Proposal for draft amendment to Regulation No. 46 (Devices for indirect vision)

The proposal of this document supersedes what was proposed in ECE/TRANS/WP.29/GRSG/2011/12. Changes to the current text of the Regulation are indicated in bold characters.

Figure 1

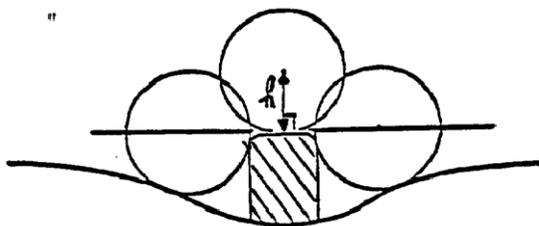
Insert new paragraphs 6.1.1.4. to 6.1.1.4.2., to read (including the addition of a new Figure 1):

- 6.1.1.4.2. If the dimension of the projection of a component which is mounted on a surface other than convex cannot be determined by simple measurement, it shall be determined by the maximum variation of the distance of the centre of a 100 mm diameter sphere from the nominal line of the panel when the sphere is moved over and is in constant contact with that component. Figure 1 shows an example of the use of this procedure.**
